**Office of River Protection, State of Washington Department of Ecology  
Tank Waste Retrieval Work Plan/Functions and Requirements Change Notice  
(Per Hanford Federal Facility Agreement and Consent Order Section 9.3)**

1. Document Title and Number: RPP-33116, Rev. 2, 241-C-110 Tanks Waste Retrieval Work Plan		
2. Minor Field Change: (Section 12.4 HFFACO Action Plan) <input type="checkbox"/> Yes: (WRPS Signature Only – Attach signed form to Primary Document for record purposes)  <input checked="" type="checkbox"/> No: Proceed to Box 3	3. Document Issue Date:  <p style="text-align: center;">06/10/08</p> <hr/> 4. Document Modification Notice Date: 12/18/12	5. Notice Number: 2012-13

9. Description and Justification of Change:  <p><b>Change Description:</b> A change is needed to identify the second and third retrieval technologies that will be used in tank C-110. A change is included to require ORP, as requested by Ecology, to provide a basis and rationale for continuing retrieval operation when equipment is degraded. General updates are also included. Changes are also included to align this TWRWP with other recently modified TWRWPs.</p> <p><b>Justifications:</b></p> <ul style="list

Figure 3-2. Tank C-110 Waste Retrieval System In-Tank Components.

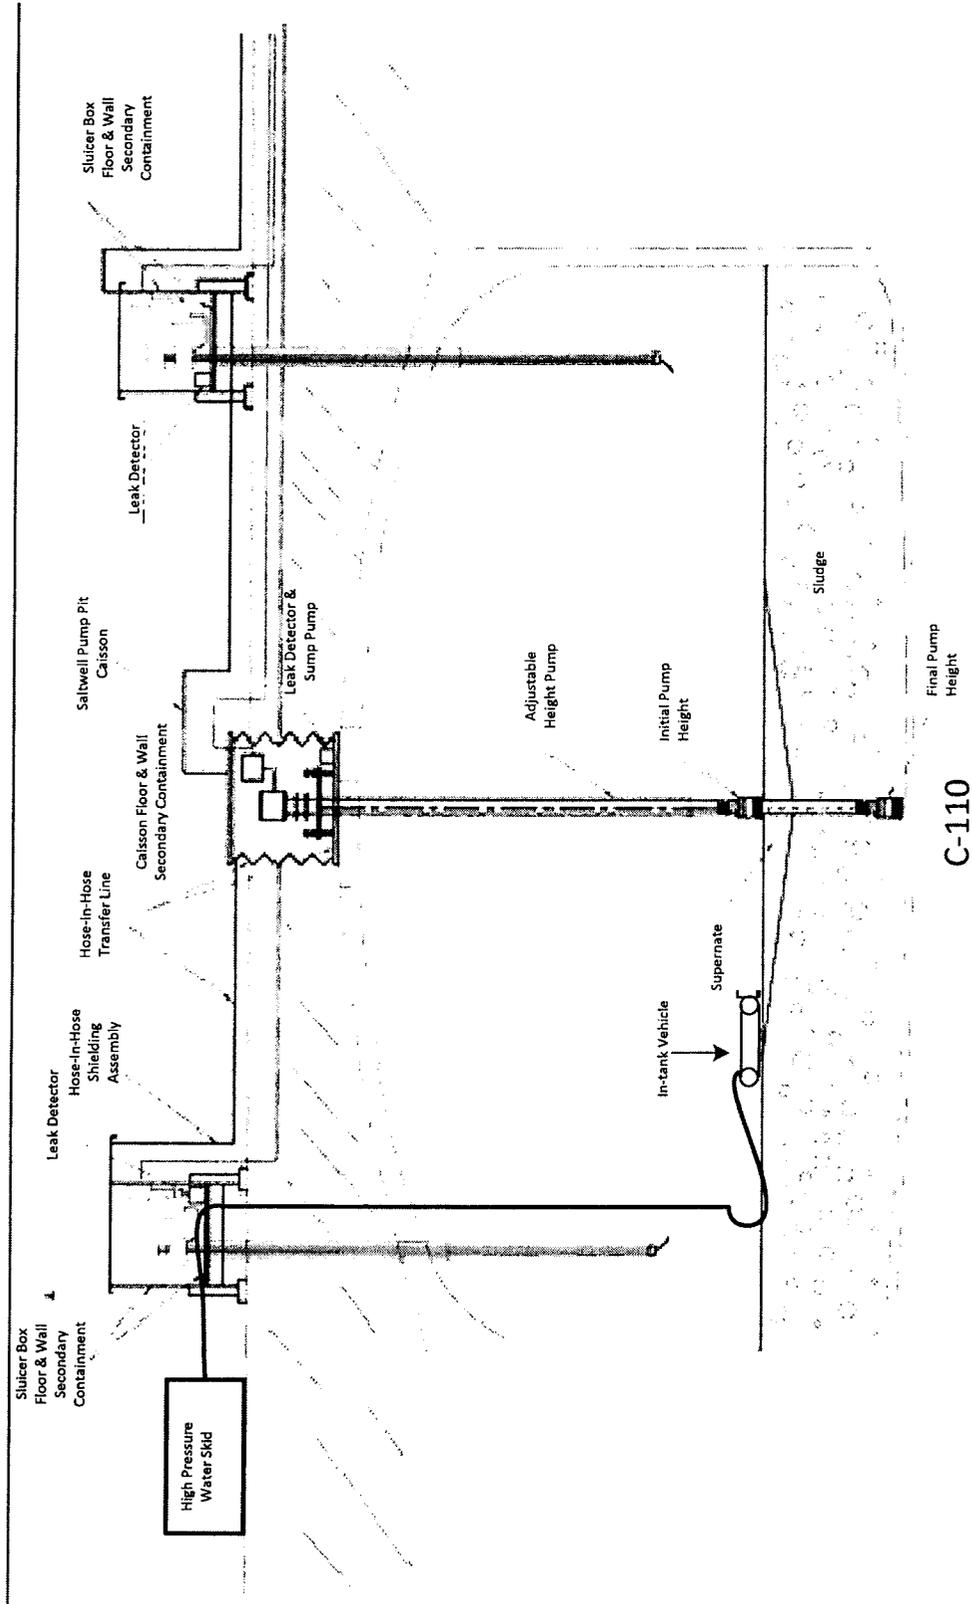
Figure 3-1 is a proposed installation of ventilation system(s) equipment to support waste retrieval operations. Alternate layouts may also be used. A sketch of the WRS installation planned for tank C-110 is provided in Figure 3-2. A potential HIHTL flow path routing and equipment layout in the tank farm is provided in Figure 3-3. As noted in Section 3.1.1, the elevation in the AN tank farm is approximately 22 ft higher than the elevation in the C tank farm.
